INSTRUCTION SHEET

To update your copy of the Marble Hill Nuclear Generating Station - Units 1 and 2 Environmental Report - Operating License Stage, please remove the indicated pages and replace them with the attached Supplement 1 pages.

QUESTIONS AND RESPONSES

This section contains U.S. Nuclear Regulatory Commission requests for additional information based on Darrell G. Eisenhut's letter of February 23, 1983, followed by the response to each question. In some cases the response includes a reference to the applicable updated sections of the text of the ER-OL.

FIGURE 2.4-A

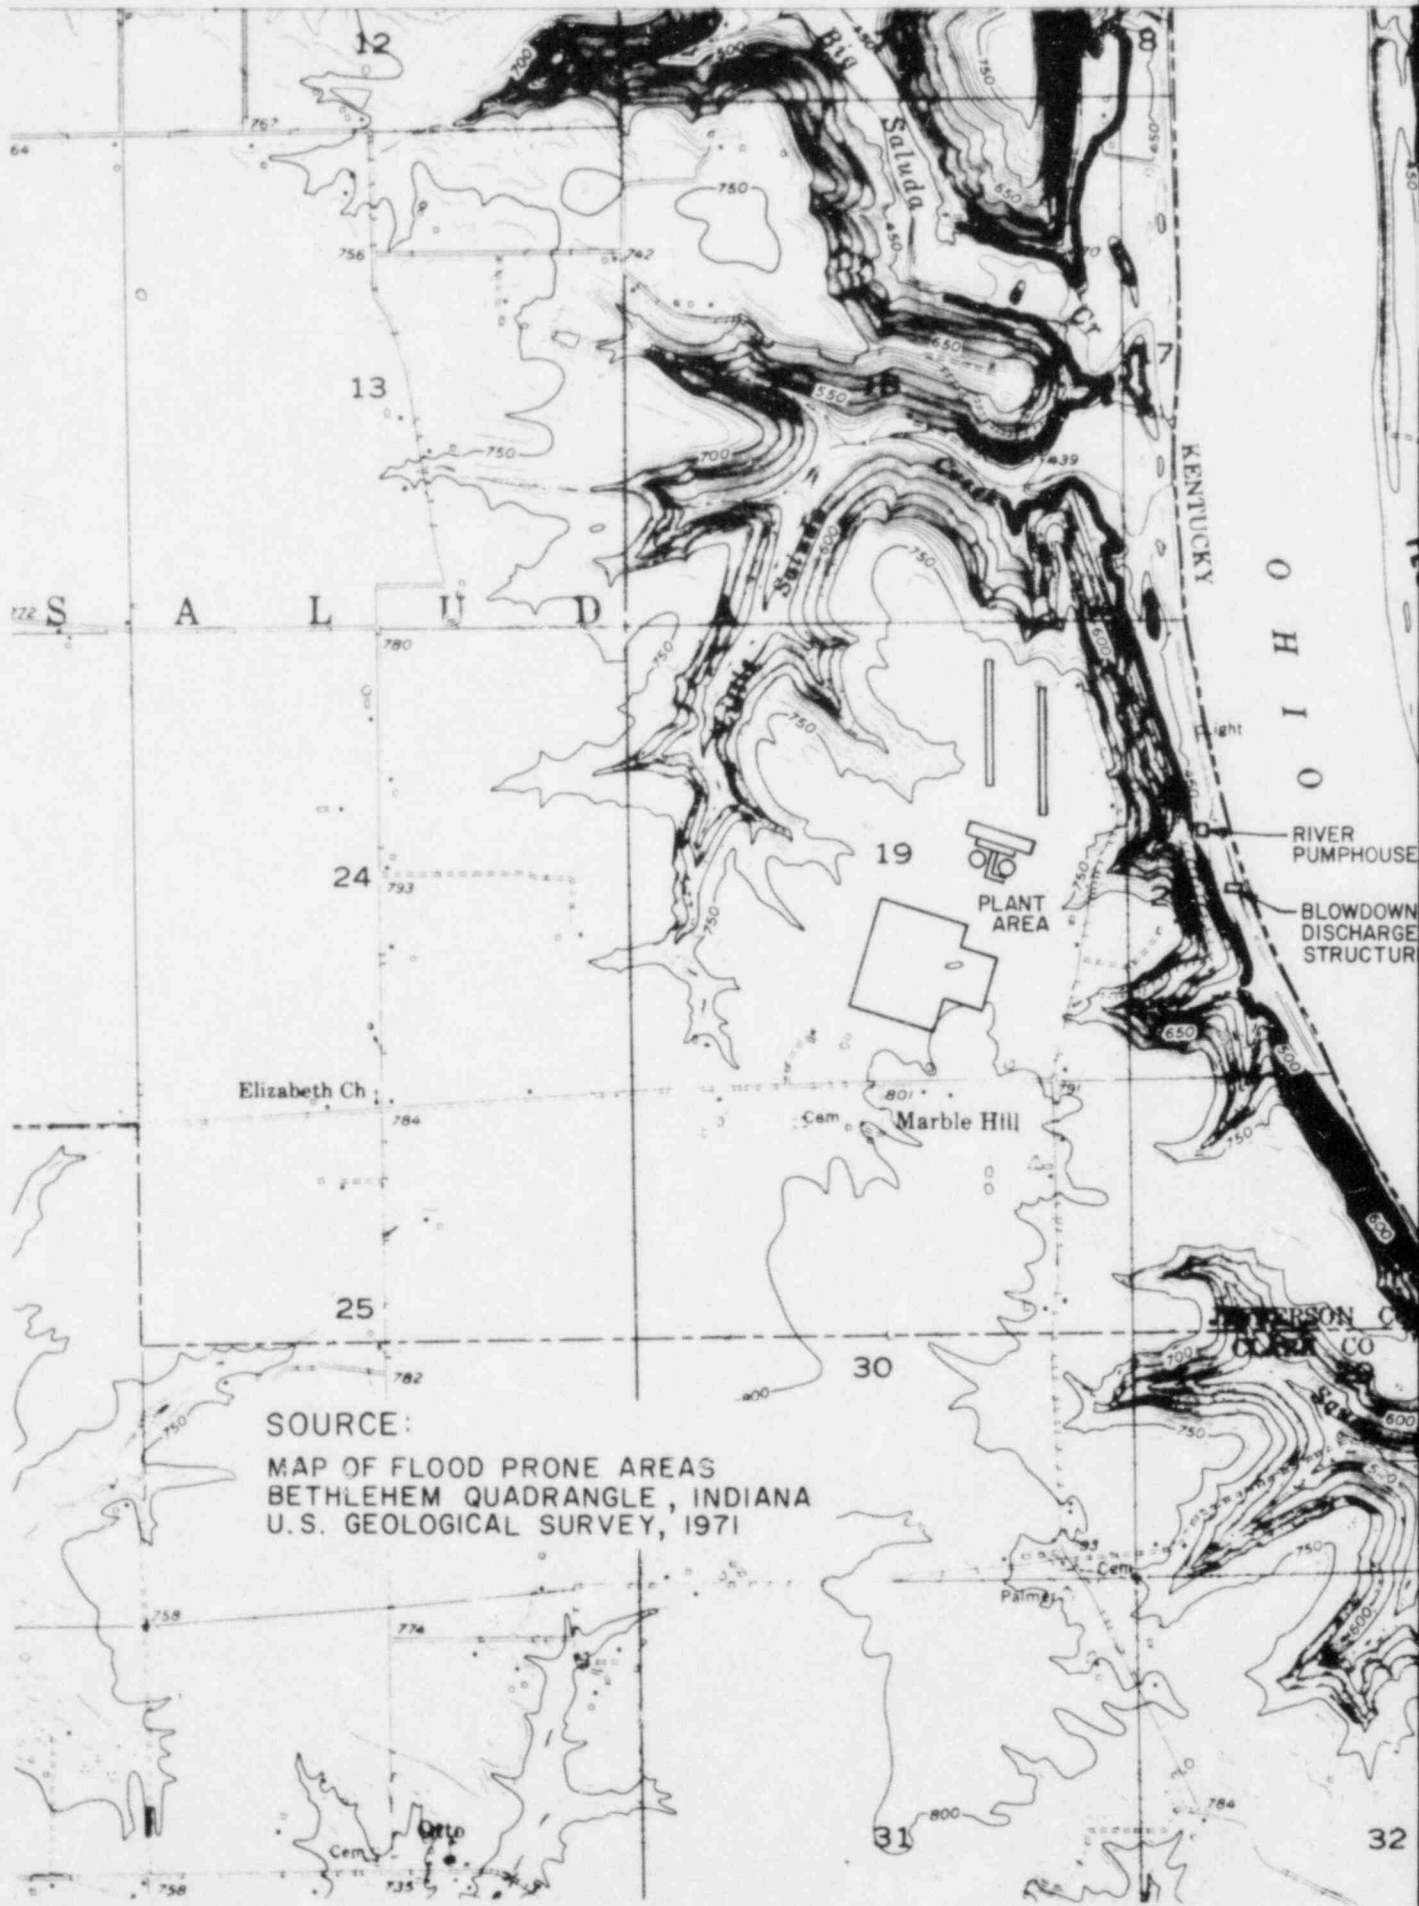
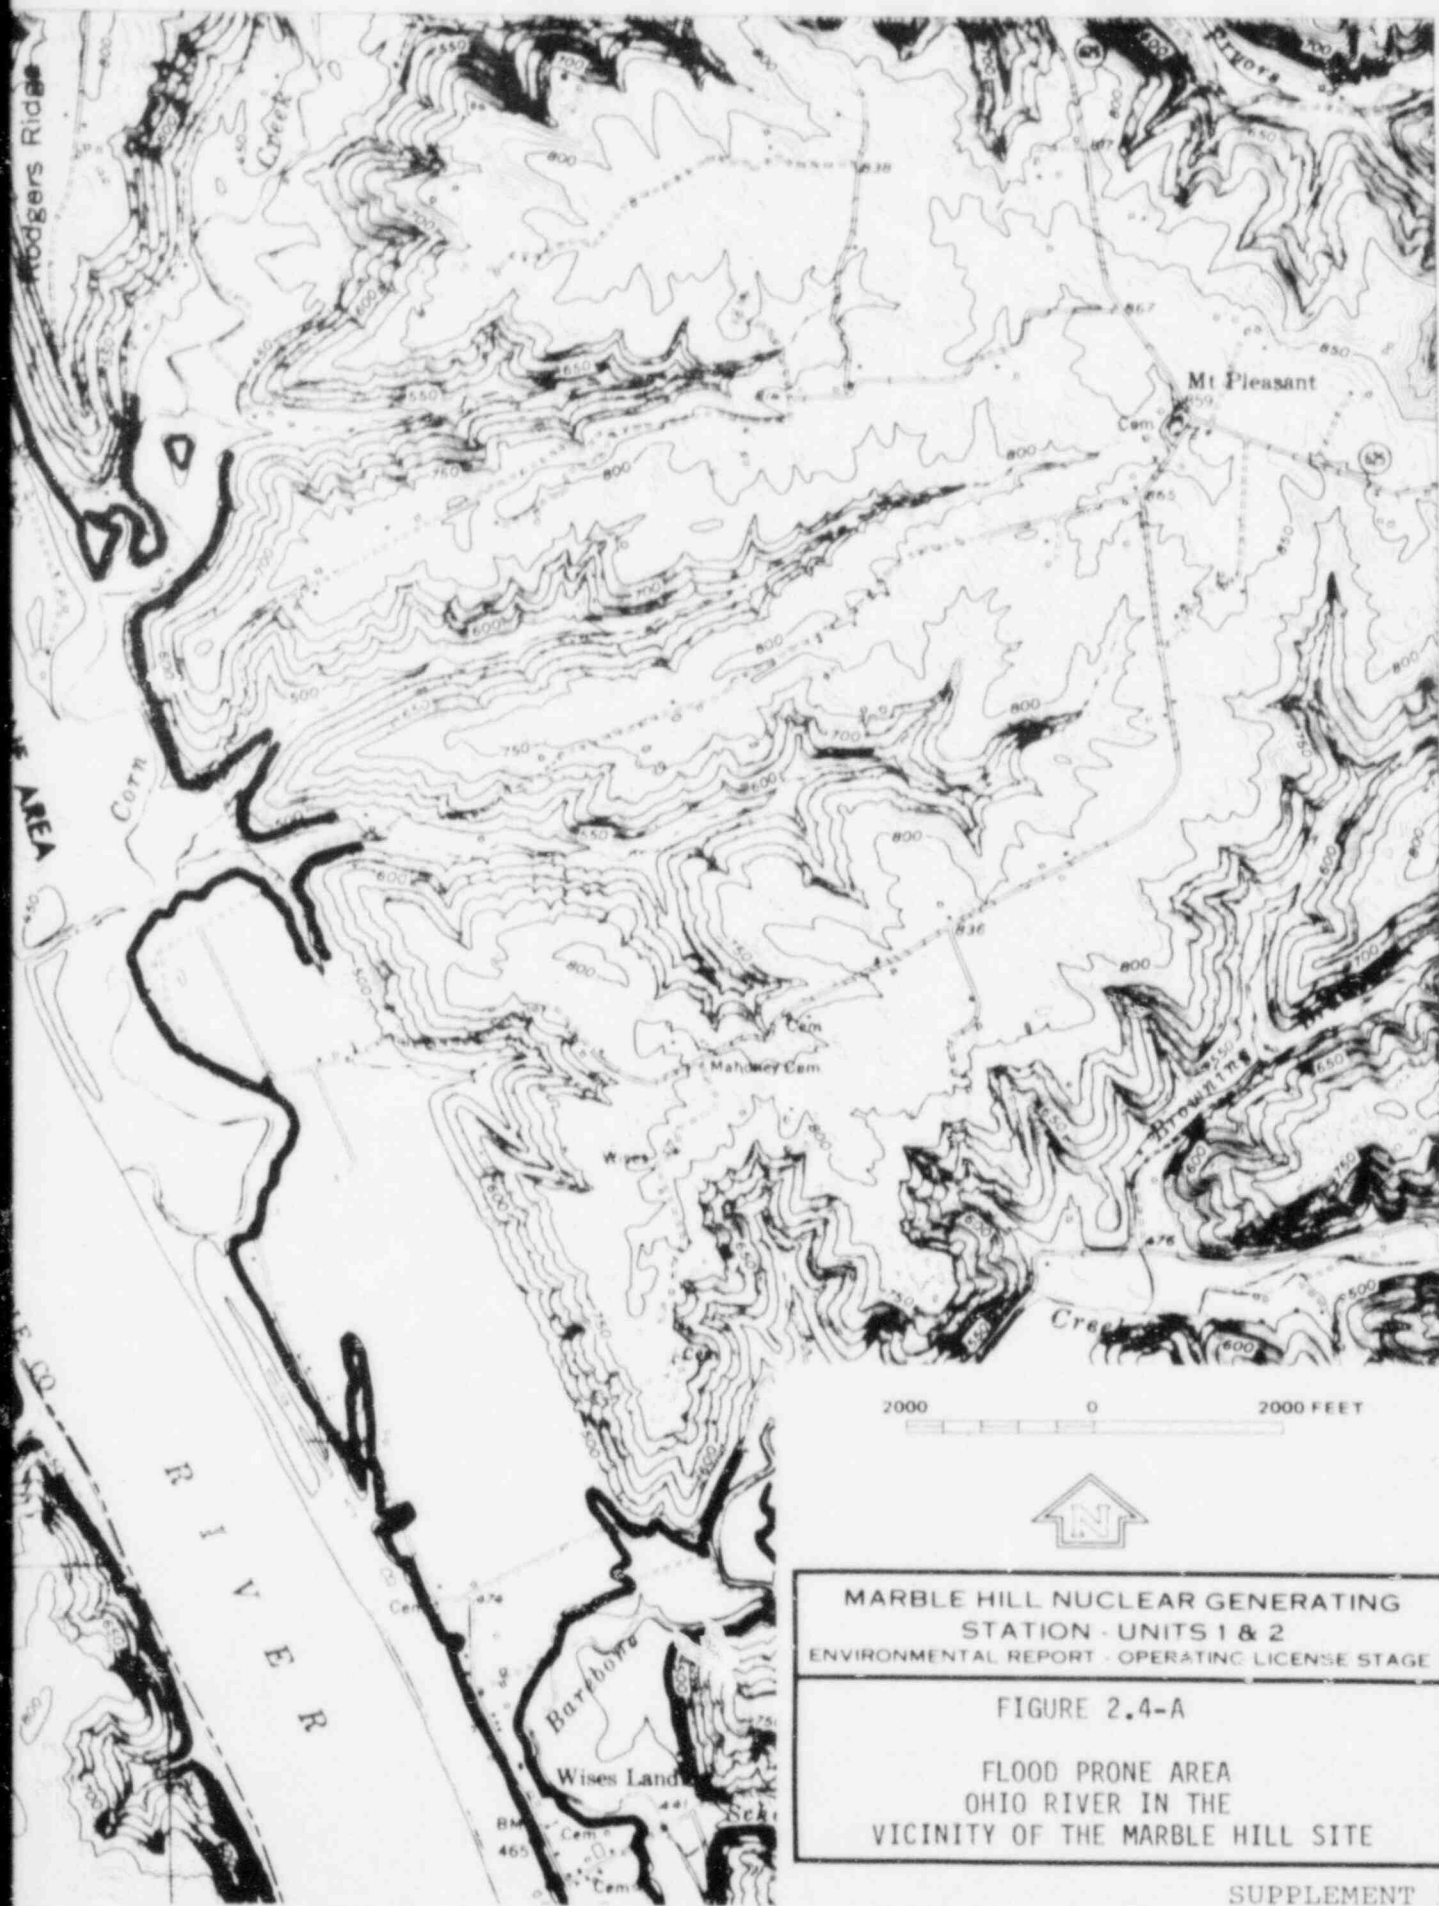
- a. Provide descriptions of the floodplains of all water bodies, including intermittent water courses, within or adjacent to the site. On a suitable scale map provide delineations of those areas that will be flooded during the one-percent chance flood in the absence of plant effects (i.e., pre-construction floodplain).

The flood prone area due to the 1% probability flood in the Ohio River in the vicinity of the Marble Hill site is shown in Figure 2.4-A. This figure was reproduced from the United States Geological Survey flood prone area map for Bethlehem Quadrangle, Indiana-Kentucky (U.S. Geological Survey 1971). Figure 2.4-B

shows the flood hazard area of the Ohio River as delineated by the Federal Insurance Administration (U.S. Department of Housing and Urban Development 1978, 1980). Figures 2.4-A and 2.4-B show the flood prone areas before the construction of Marble Hill 1&2.

The main plant structures, river pumphouse, and blowdown discharge structure constructed for Marble Hill 1&2 are also shown in Figures 2.4-A and 2.4-B. It is evident from these figures that the main plant area, including most of the plant-related facilities, does not alter the floodplain of the Ohio River or its tributaries, and hence does not affect the flood prone areas.

FIGURE 2.4-C

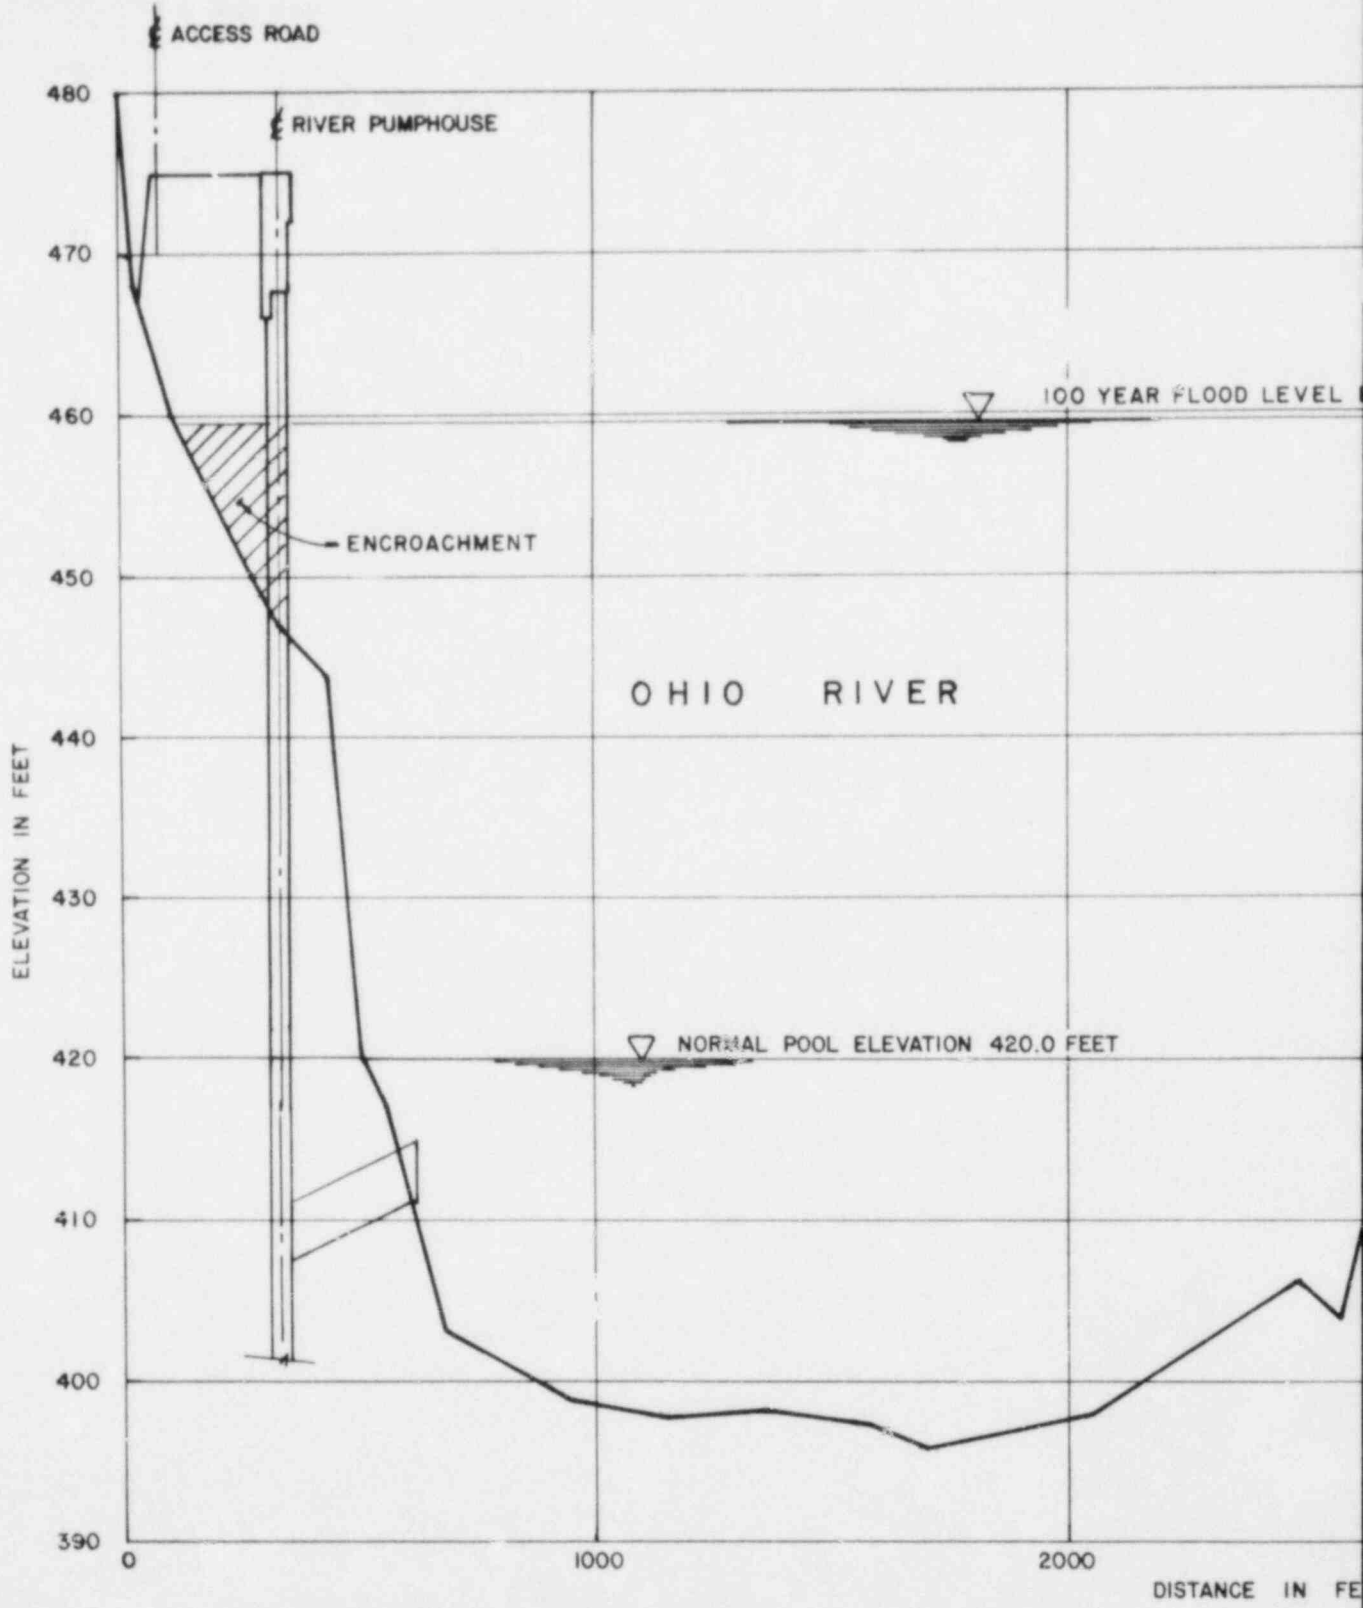
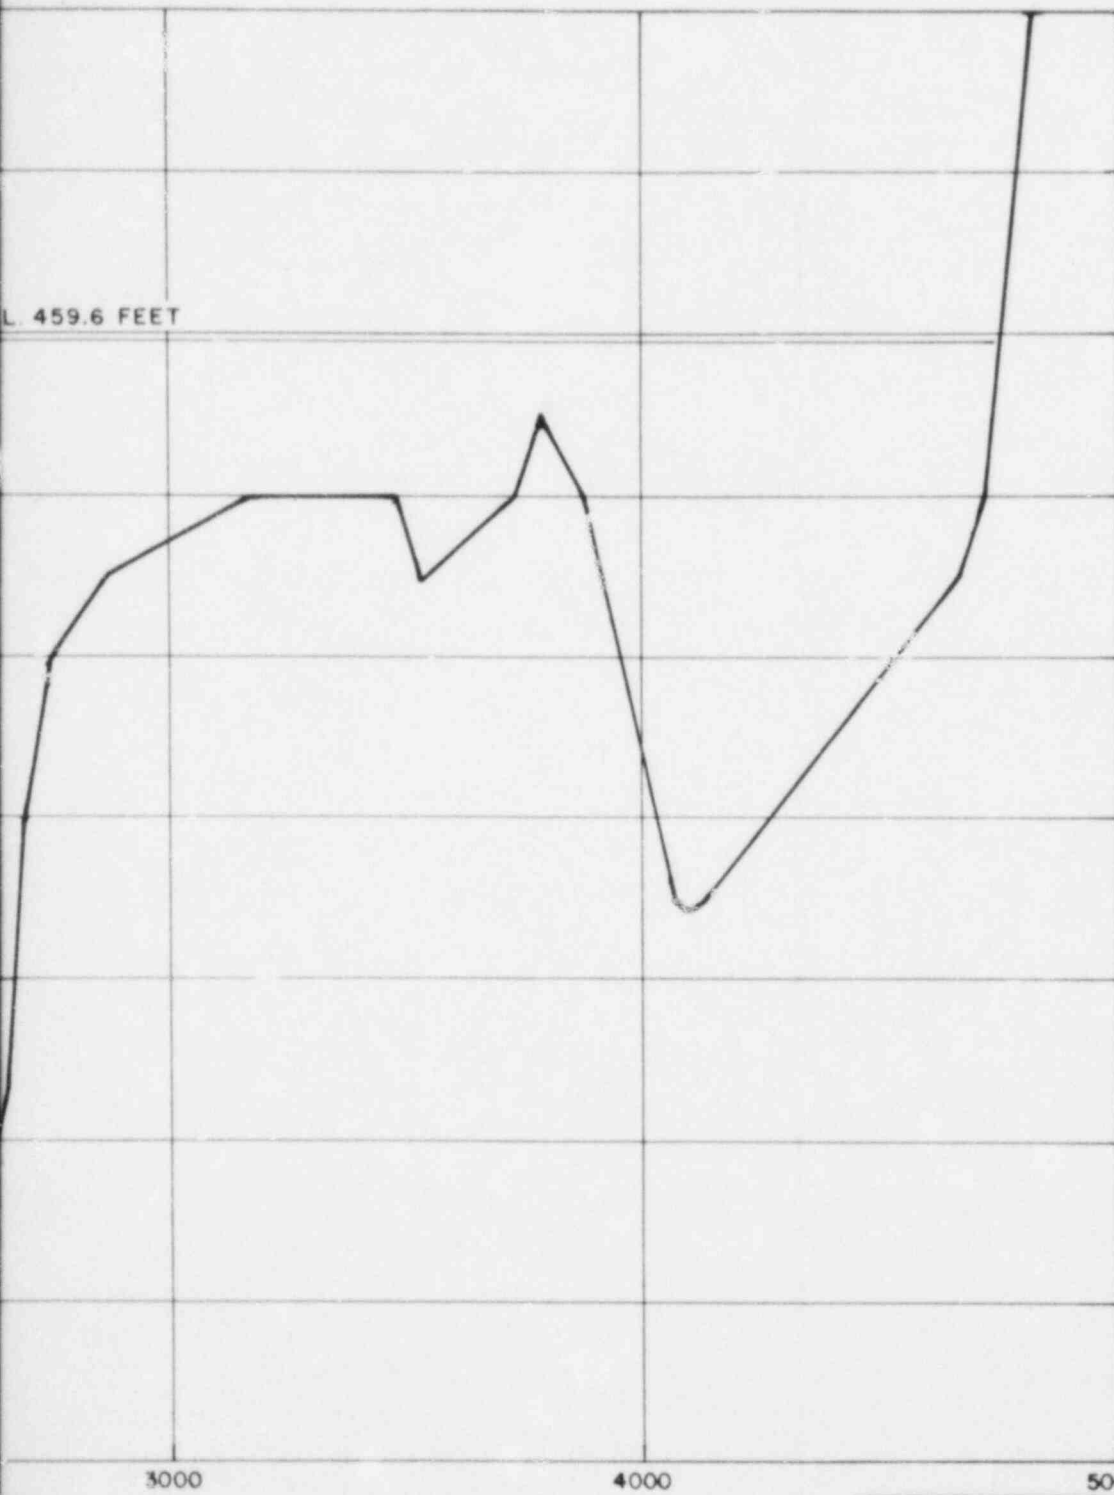
- c. Identify, locate on a map, and describe all structures and topographic alterations in the floodplains.
- d. Discuss the hydrologic effects of all items identified in c. above. Discuss the potential for altered flood flows and levels, both upstream and downstream. Include the potential effect of debris accumulating on the plant structures. Additionally, discuss the effects of debris generated from the site on downstream facilities.

The river pumphouse and the blowdown discharge structure are the only plant-related facilities that might have a detectable effect on flood levels. They are located in the floodplain of the Ohio River, near River Mile 570, as shown in Figures 2.4-A and 2.4-B. The river pumphouse and the approach road to the pumphouse occupy a small portion of the Ohio River floodplain as shown in Figure 2.4-C. The intake to the pumphouse is by submerged intake screens connected to the pumphouse by pipelines buried under the existing grade of the floodplain. The blowdown into the river is by submerged discharge through a buried pipeline that extends into the river. Therefore, the blowdown discharge structure and intake pipelines do not affect the flood prone area.
